# Nagan Family Objection to Council Development Application Number MCUI 2024\_5682/1 Sand Extraction Proposal on Lot 1 on RP893855, Bonnie Doon Road, Killaloe, 4877

Re: Council Application Number MCUI 2024\_5682/1

Figure 3: Extract of Site Plan

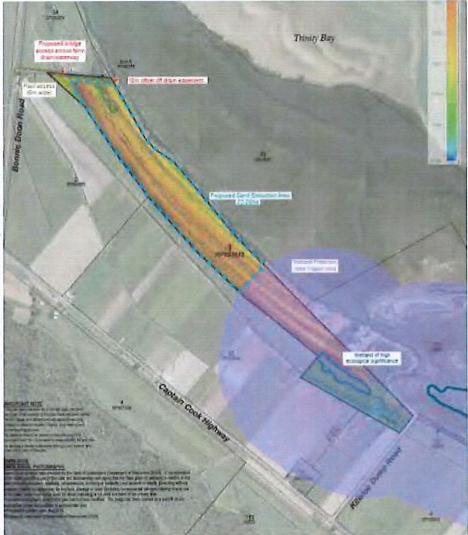
☐ The scale of the sand extraction activity is expected to be in the order of 20,000-30,000 tonne per year;

There is no demonstrated economic, planning and/or community need for a further extractive industry in the Shire. The question of need is decided from the perspective of the community and not that of the applicant. The number of properly made objections support there is no need for a further sand quarry with DSC.

Below: Pioneer Concrete Soil Logs from 1994 (30 years old), do not include any testing for PASS material. rps letter to council 26 November 2024.

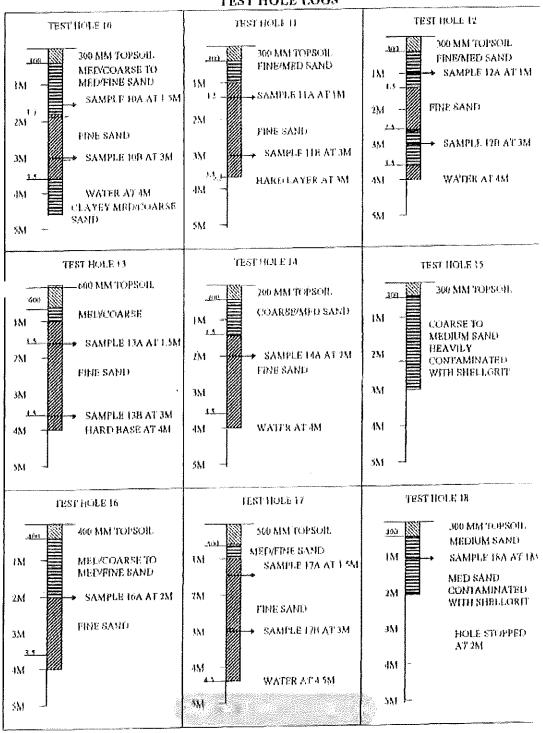
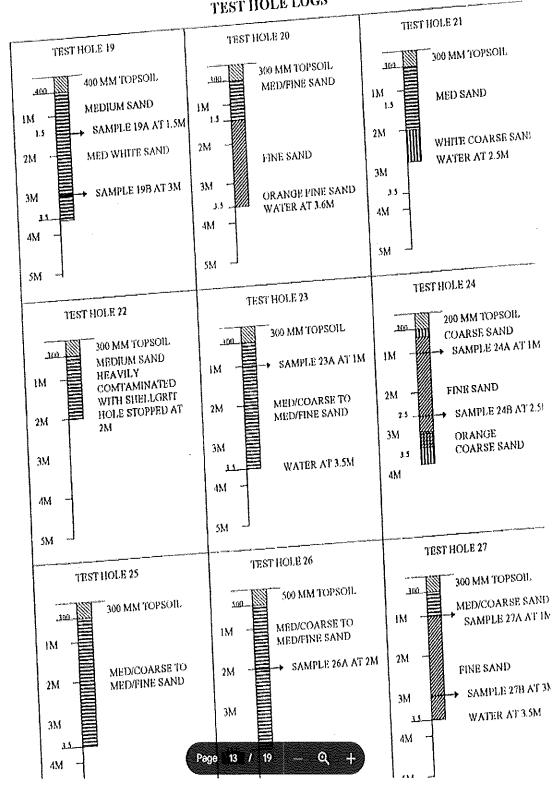
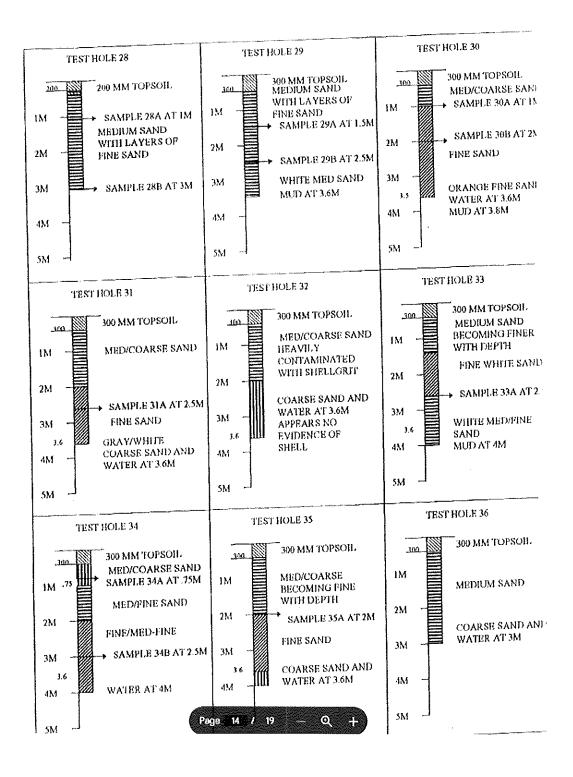
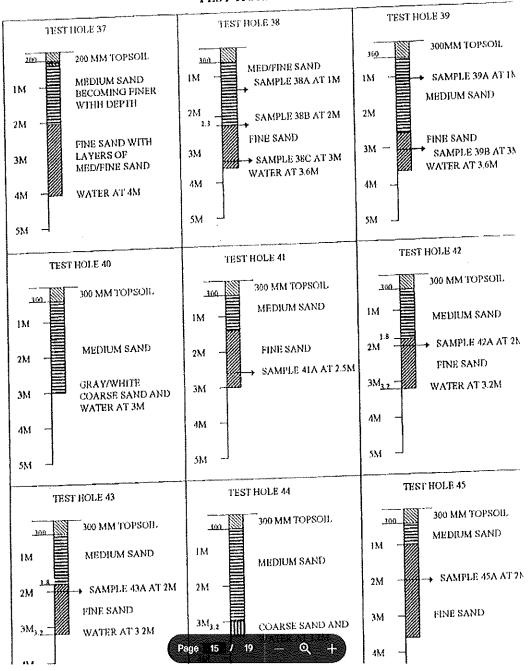
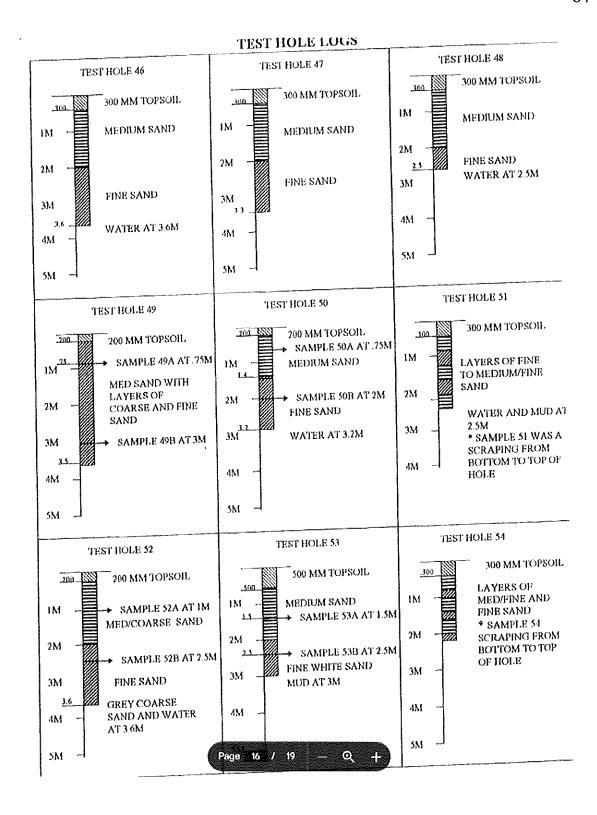
- Soil Logs (Council Request Item 3)
   The applicant admits that historical soil logs, without sample data or cooridnates from 1994 do not include testing for acid sulfate soils. This failure to provide updated and site-specific ASS testing leaves critical gaps in the assessment.
- 2. Post-Extraction Storm Tide Analysis (Council Request Item 4)

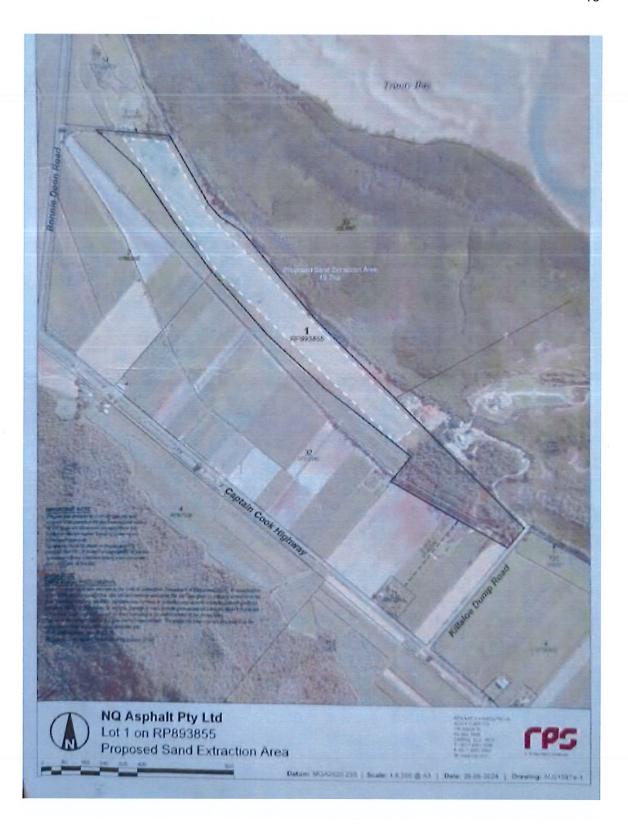
When one turns to the site plan for the proposed sand extraction dated 26 August 2024- DRAWING AU 015874-2 the area has been greatly reduced to avoid the wetland protection area trigger area and yet, the proposed sand extraction area is noted at 22.29 hectares.

Figure 3: Extract of Site Plan

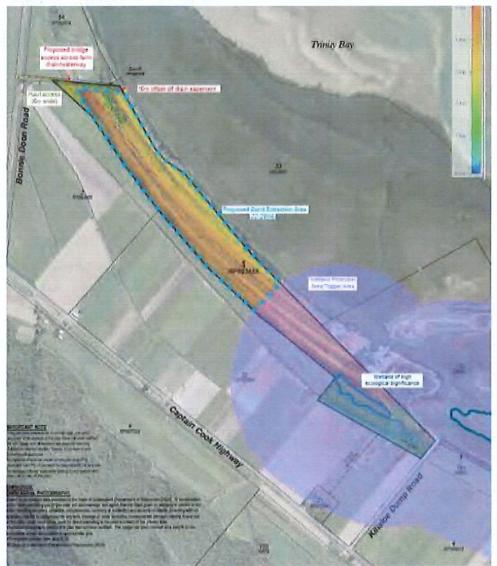
Our submission: rps town planning report's approach to mitigating impacts on matters of environmental significance is insufficient. The Natural Areas Overlay mandates avoiding impacts on wetlands, waterways, and high ecological value areas. Buffering and preservation of wetlands and waterways are critical for alignment with this overlay. (8.2.7 Natural-areas-Overlay)

#### ACCESS POINT TO LOT 1 FROM UN-NAMED ROAD

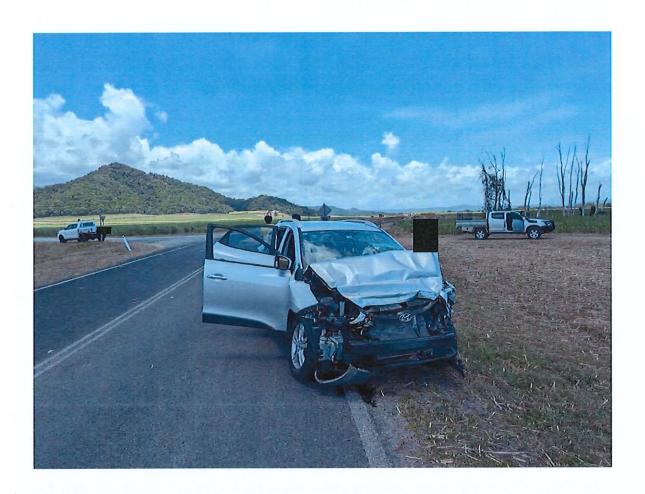
- (1)(i) IMMEDIATE DANGER to our children and pets. Site Based Management Plan. Page 14 Trucks travelling at 40 km/h speed across site and presumably service road unacceptable. A twenty tonne truck will kill or severely maim our children and pets.
- (1)(ii) Increased heavy vehicle traffic will lead to road degradation and safety hazards.
- (1)(iii). The Mossman Local Plan emphasizes maintaining local character and managing traffic associated with agricultural and community uses. An increase in heavy traffic from sand extraction will in our submission conflict with the intent to preserve infrastructure for residential and rural uses (7.2.3 Mossman Local Plan)

- (1)(iv) The proposed access point from the un-named road is 60 metres from our residence. see attached plan marked "G"
- (1)(v) It would seem this has been chosen as the access point rather than the north western corner of Lot 1 on RP 893855 as previously advised by rps (see rps letter marked "H" to us of 28 June 2024) because an area of approximately 5000m2 located north west of the delineated area of Lot 1 is under cane crop to the Coulthard family who own Lot 2.
- (1)(vi). Further a DNR search notes there is Easement B in Lot 1 for benefit of Lot 2 for drainage purposes.
- (1)(vii) The Development Application should also be refused because it is not safe to haul from the 10 metre road reserve onto
